I beg to report
that the drainage
connection of the house
on plot No 117. C.B.
Kutchiwara lane
No. 1 has been inspected
by you with the ag
Chief Engineer.

Regarding plot No. 117, C-6 Market Quarter.

PLAN OF PROPOSED HOUSE
ON PLOT No. 117-C-6 MARKET QUARTER.

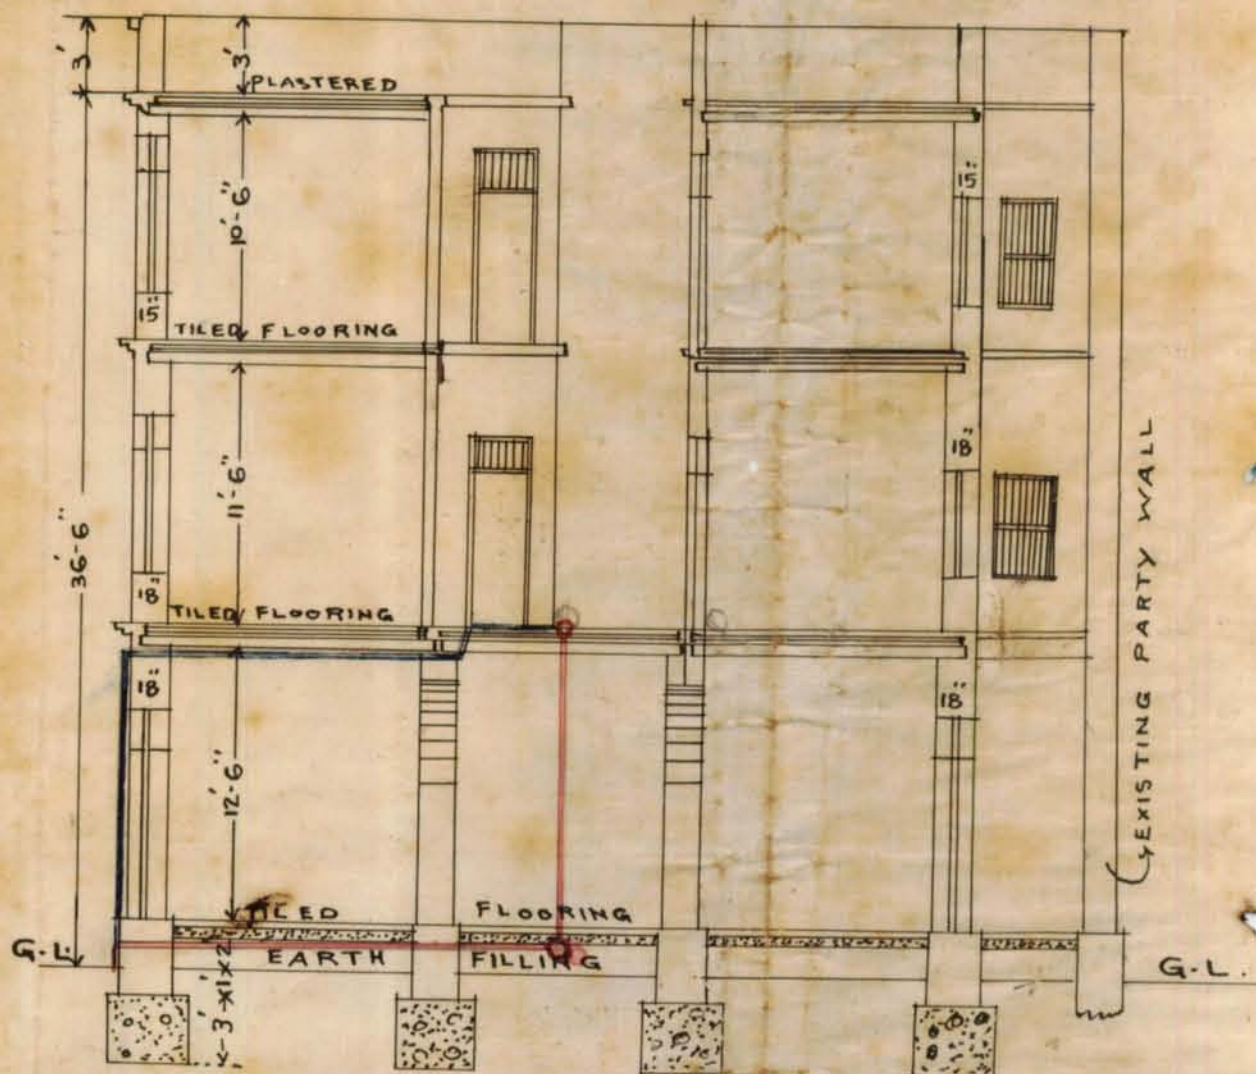
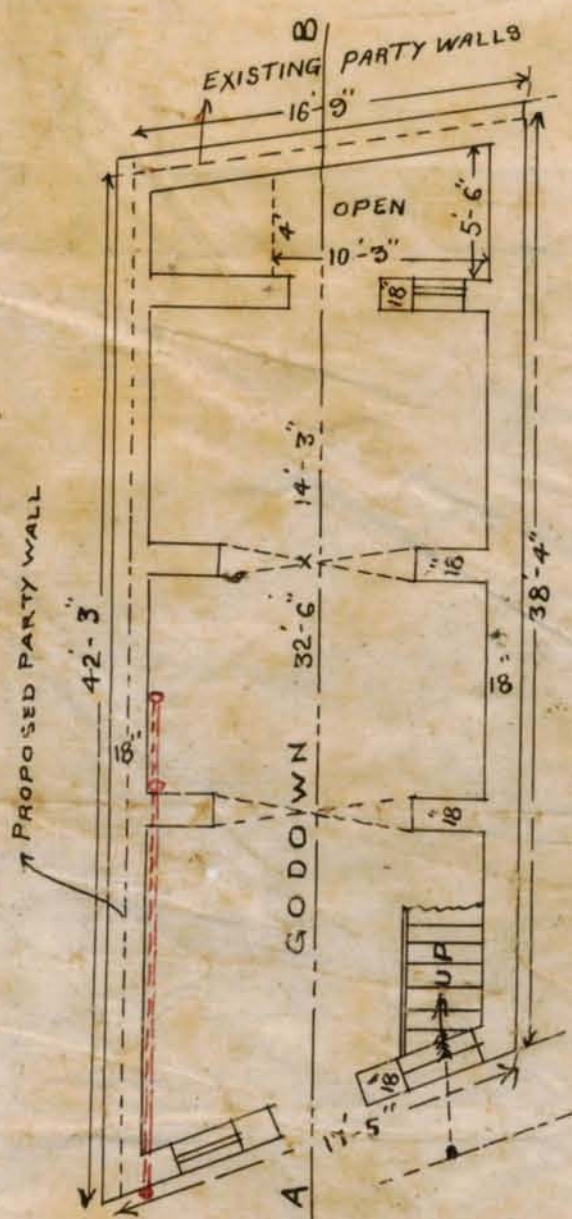
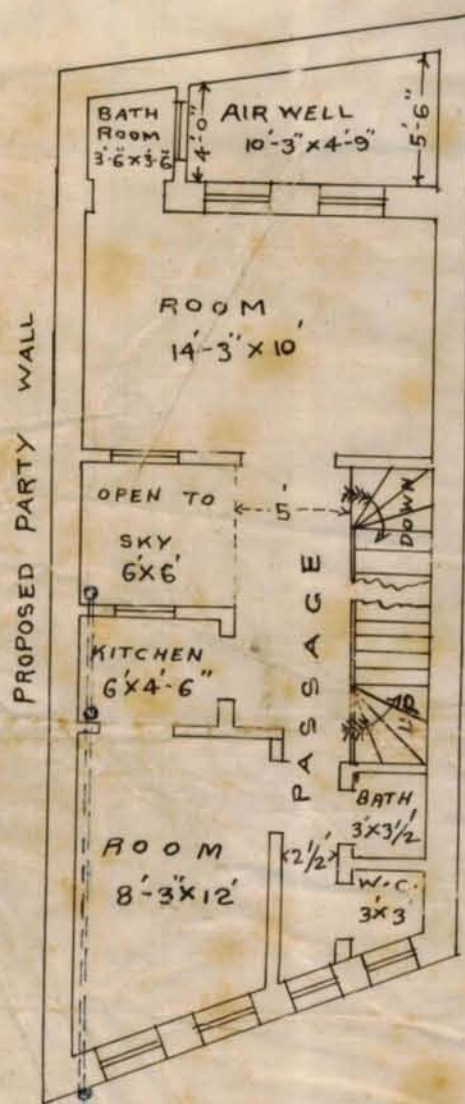
Messrs Yusafali Mahomedali Kula Lukmanji Ghulam Hoosein Allibhoy Karimji, President and Secretary of the Faiz-allawari are hereby notified to remove the drainage work of building recently erected on plot No. 117.0-6 Market Quarter as the same has been laid in a manner which is very insanitary. The soil-pipe from the drainage fittings is taken down on an internal wall to the ground floor contrary to the Bye-laws and joins the drain in an enclosed space which cannot be permitted as such connection must be made in a space entirely open to the sky.

no drainage fittings can possibly be put into a house
not sanitary conditions unless the soil pipe emerges
on the side wall or an external wall from ground
floor level and also be open to the sky as a main drain
provided a brick or concrete structure & drain carried
in concrete carries up the building where such
is required for the structure of the house.
It is not possible to provide any other arrangement
to make suitable as this belongs to the main
of the ground floor & small receptacles for water
included building work.
The same must be a well known rule.

A plan is submitted showing in blue how the soil pipe has been taken and in red how it ought to have been taken. *It is attached.*

A plan is submitted showing in
blue how the soil pipe has been
taken & in red how it ought to
have been taken.

A plan is submitted showing in blue how the soil pipe has been taken and in red how it ought to have been taken. *7c is attached*

The soil-pipe from the drainage fittings ^{is} must be taken down on
an ~~external~~ ^{internal} wall to the ground floor which ~~must also be open~~ ^{cutting to the sky and join the drain}

to sky and a manhole provided in such open space and therefrom

a drain encased in concrete carried under the building to the
street. ^{is a enclosed space. which cannot be join the}

from the kitchen to enter the drain on the ground floor in a
space entirely open to sky.
